Question/ Answer

Open call to tender EMSA/OP/17/2014 concerning contracts for provision of maritime surveillance services from TerraSAR-X/Tandem-X/PAZ satellite images

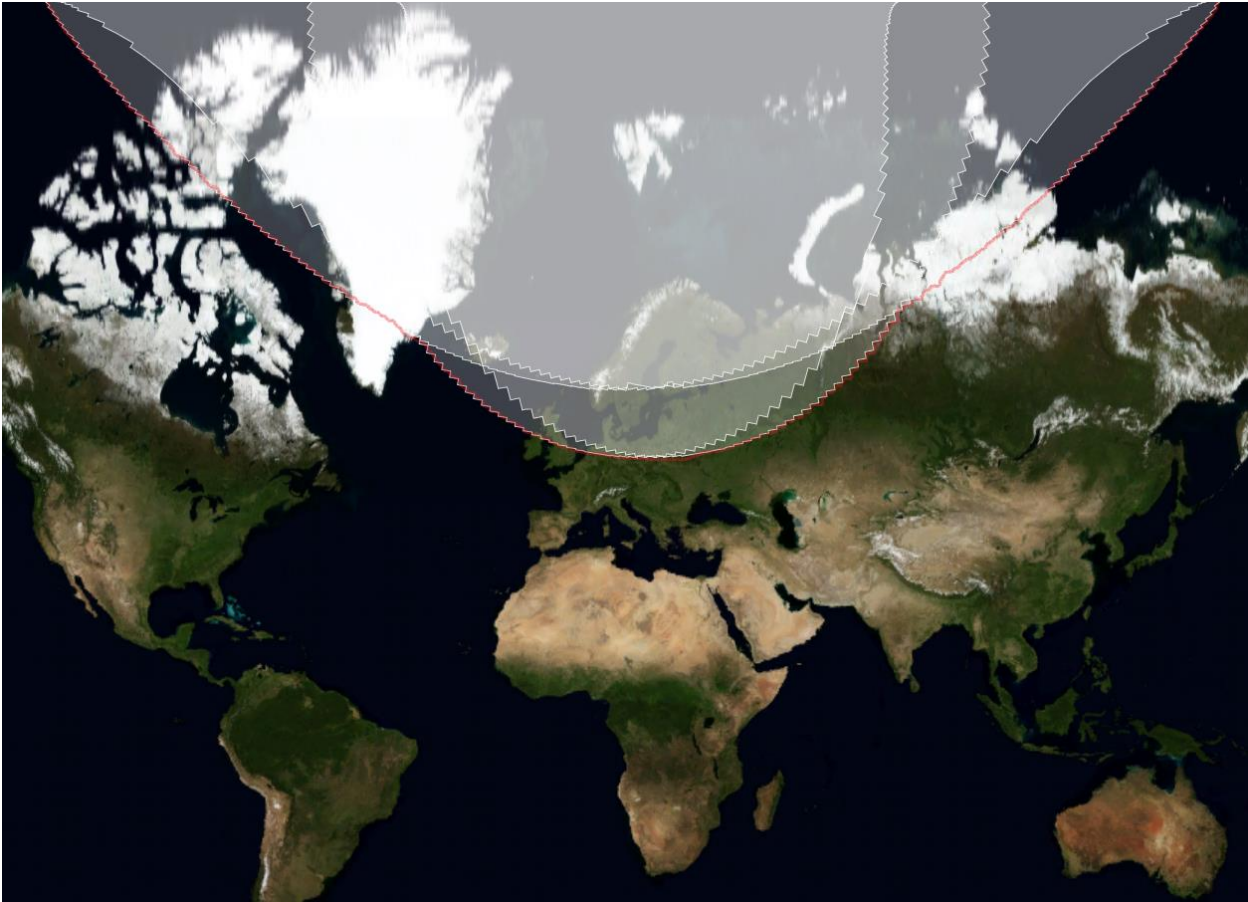
With reference to section 5.0.0.3, Tender Enclosure 1 Technical Specification for tender;
Can you confirm that EMSA plans to procure required maritime surveillance services within the greyed area in Figure 1 from the already contracted service providers in the EMSA/OP/15/2013 frame agreement, and that this greyed area is not then considered part of the bidding for services in this tender OP/17/2014?

If the required maritime surveillance services based on TerraSAR-X/Tandem-X images can be provided in NRT 30 minutes, by existing contractors under Framework Contract 2014/EMSA/OP/15/2013, then service orders shall be placed using this contract. Therefore, the greyed area is excluded with respect to delivery of NRT maritime surveillance services as requested under this Invitation to Tender EMSA/OP/17/2014.

Due to a clerical error the area in Fig. 1 did not accurately reflect 'The area covered by an existing contract for Terra-SAR-X/Tandem-X valued adding services'. The correct Figure 1 is provided below. All acquisitions in the area above the red line are excluded from the scope of Invitation to Tender EMSA/OP/17.
